FLOOR PLAN SHOWING CEILING
 JOISTS ABOVE - 1/2" = 1'-0"

DECEMBER 21, 2004

380 DANFORTH - BLOOMFIELD

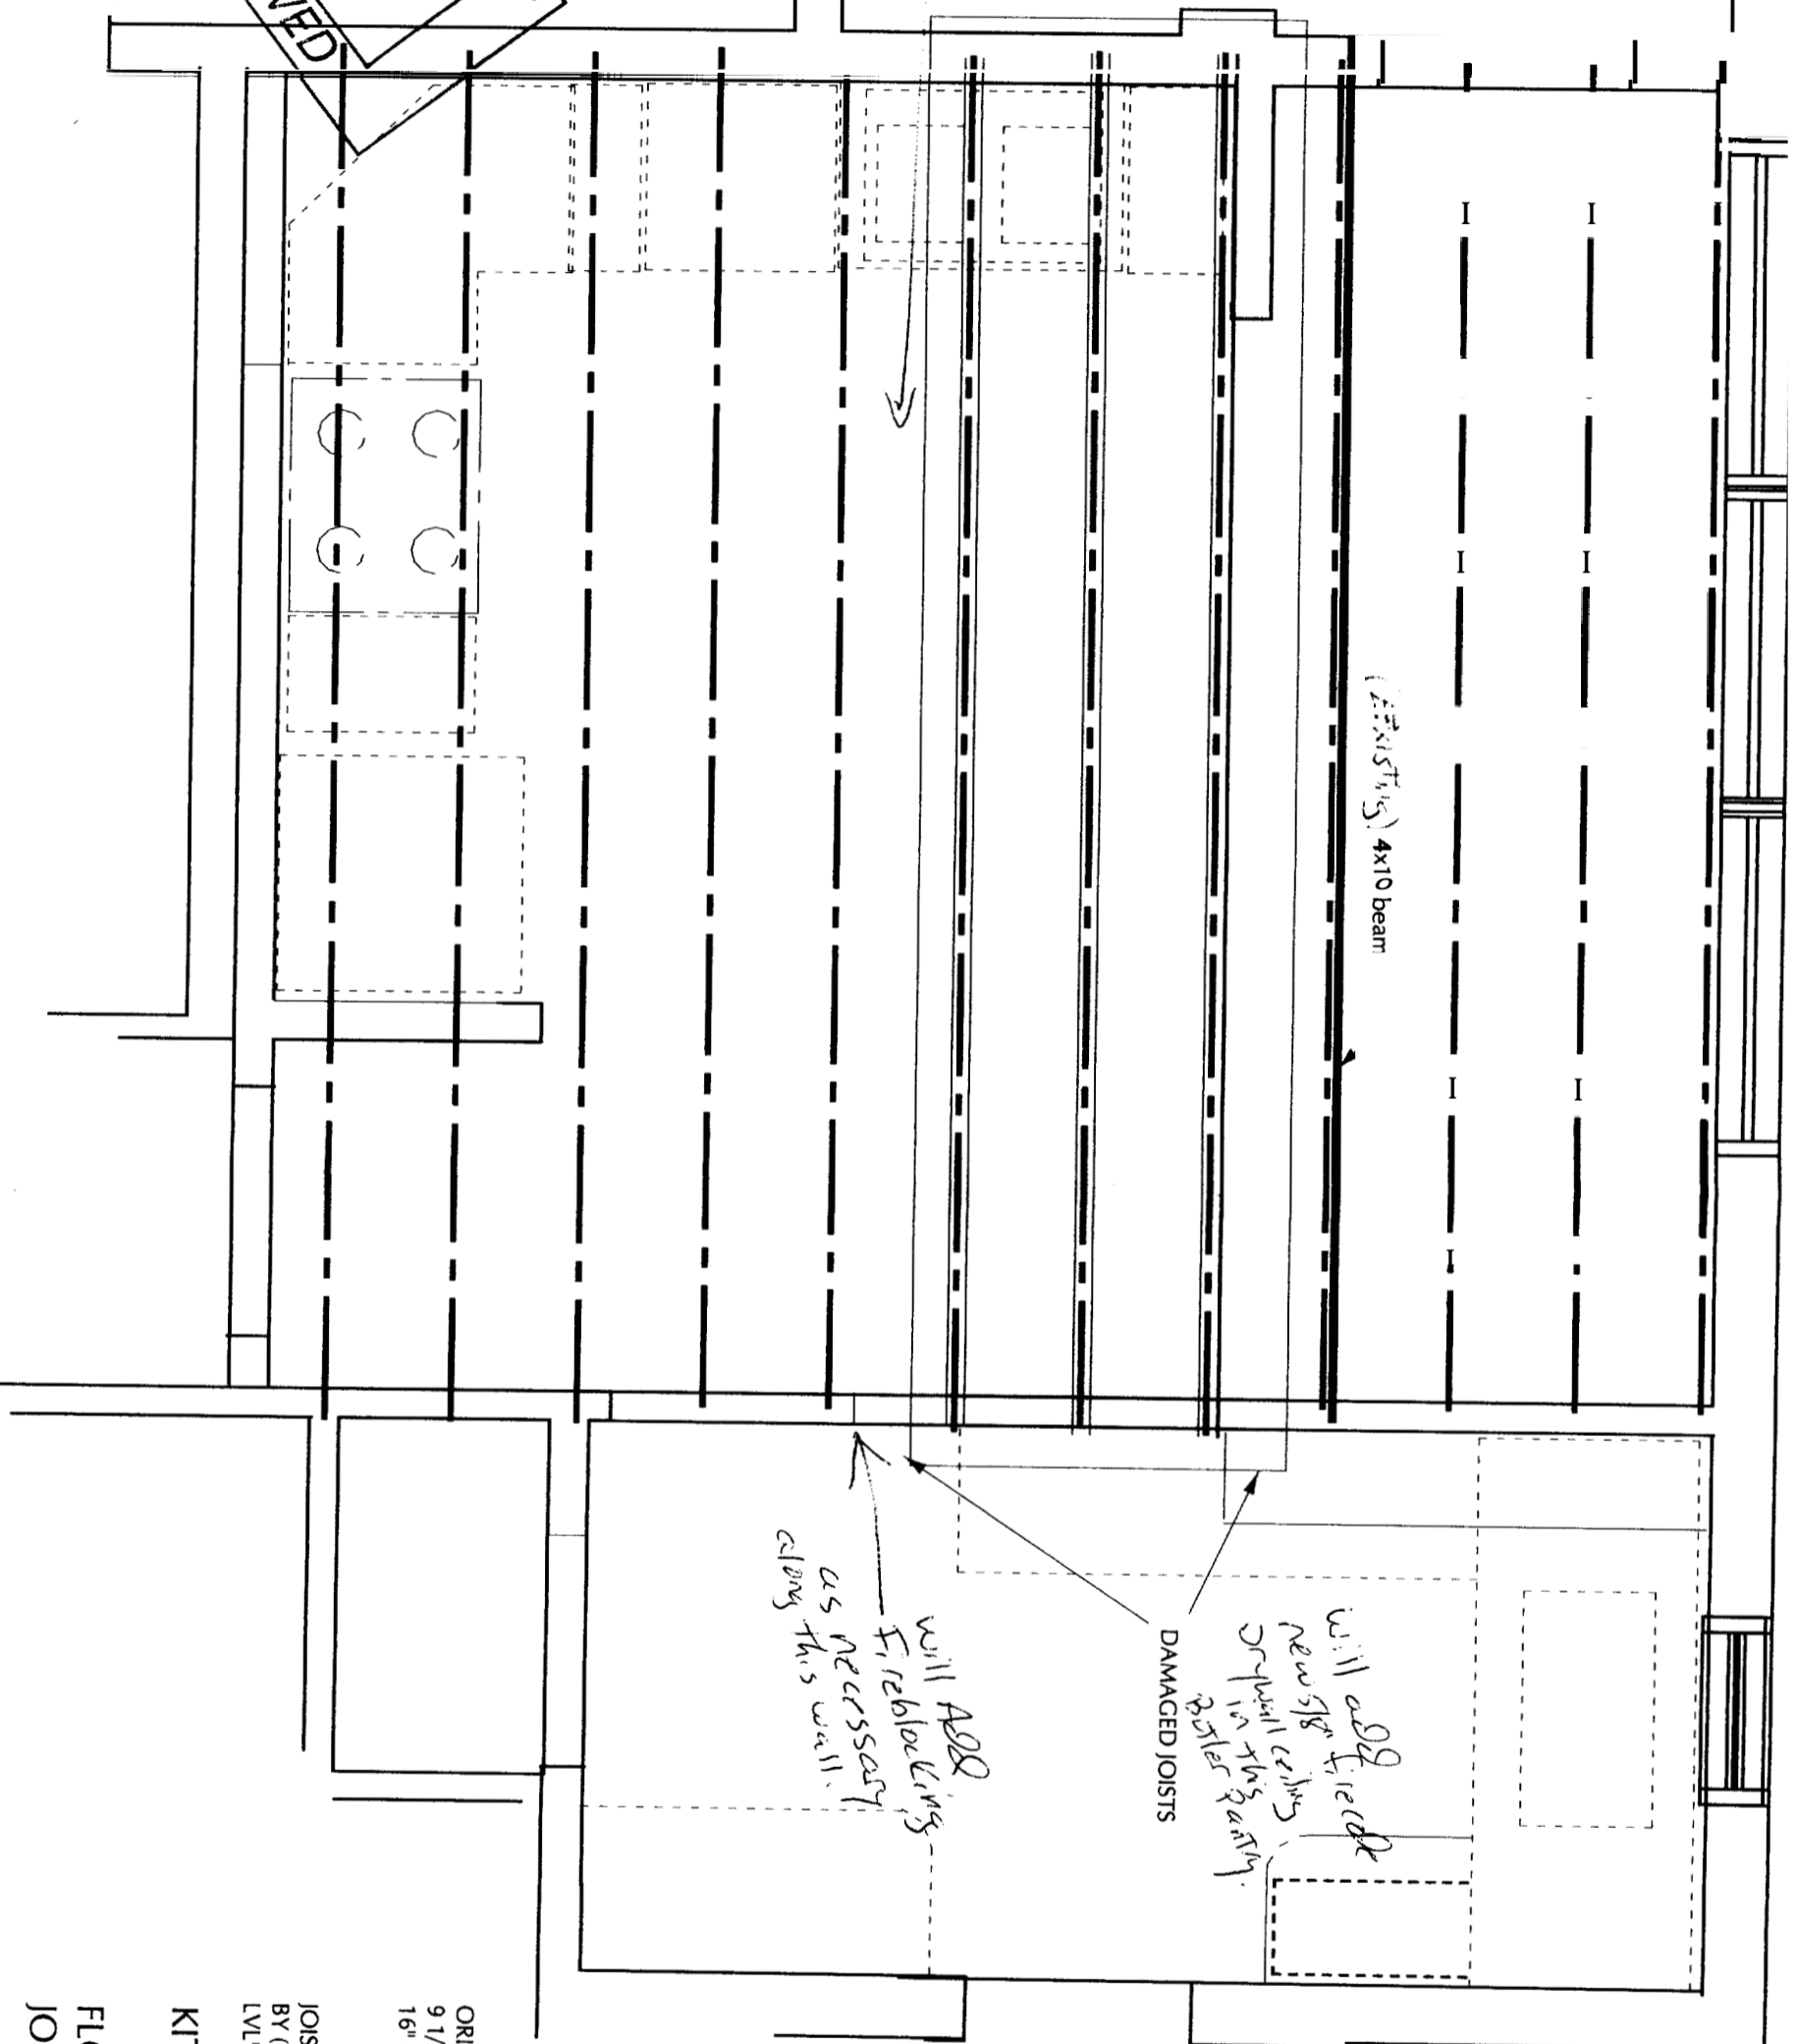
Will use
 5/8" steel
 for fire code
 on ceilings

will add fire code
 new 5/8" steel
 in this party.
 replace
 DAMAGED JOISTS

will ADD
 fire blocking
 as necessary
 along this wall.
